Office Action Summary	Application No.	Applicant(s)
	09/768,912	KAWAI, HIROJI
Examiner	Art Unit	
James Menefee	2881

DETAILED ACTION

F I G. 7E

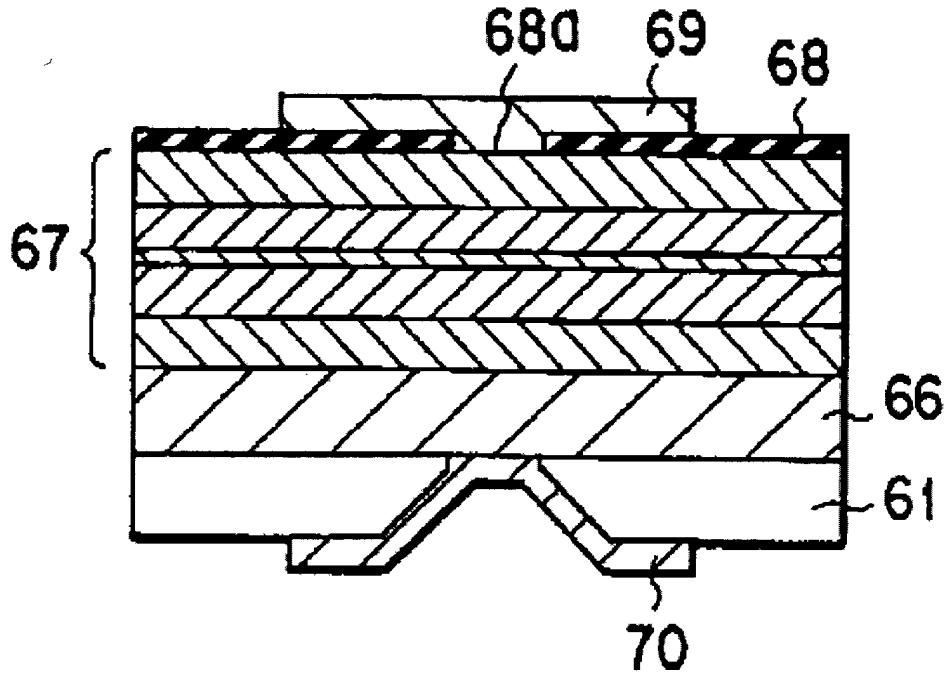
Claims 9-12 are rejected under 35 U.S.C. 102(b) as being anticipated by Nunoue (US 5,905,275). Nunoue discloses the limitations of claims 9-11, namely a semiconductor device where a single crystal sapphire substrate 61 has a GaN semiconductor laser 66-69 formed on a major surface. An electrical connection to the device is made through an electrode 70 in a hole formed on the substrate (Fig. 7e, col. 8 line 14 - col. 9 line 58).
